To: Planning Commission  
From: Urban Design Committee  
Date: November 16, 2015  
RE: **Conceptual Location, Character and Extent Review of modifications to Hull Street, from Chippenham Parkway to Arizona Drive**

The application is for conceptual location, character, and extent review of modifications to Hull Street, from Chippenham Parkway to Arizona Drive.

*Typical section proposed in the Hull Street Corridor Revitalization Plan (page 97)*

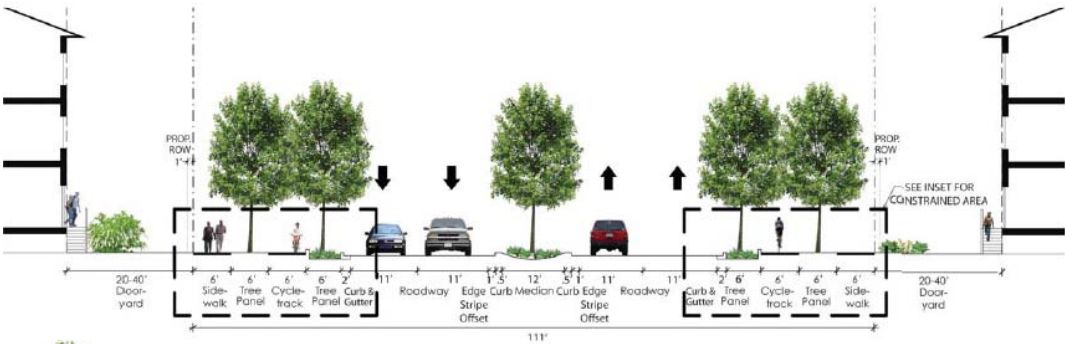
The portion of Hull Street in the plan coincides with the section of Hull Street that is the subject of this proposal. After studying the corridor, the plan set forth the dual objectives of expanding non-auto travel options and changing the physical image and character of the street. Considering several options, the plan recommends an alternative that “best addressed the safety, mobility and revitalization objectives of the effort was a “typical section” that provided separate facilities for all modes – pedestrians, cyclists and vehicles – as well as medians and planting strips that made dramatic changes in the visual impression of the corridor” (page 97).

The proposed typical section includes: a continuous pedestrian sidewalk network and crossings; a separated cycle track/bicycle way on each side of the corridor; a landscaped buffer between pedestrians and bicycle way and travel way that provides sufficient space for comfortable and furnished transit stops and amenities; a landscaped median that provides accommodation of left turn lanes at intersections to reduce rear end and rear-angle crashes; and provide safe pedestrian crossings with a minimum 6' pedestrian refuge even when the median is reduced to provide a left turn pocket; two travel lanes in each direction to maintain vehicular capacity and operation; and a gutter pan that can channelize water into low impact development (LID) features in the planting buffer (page 97).
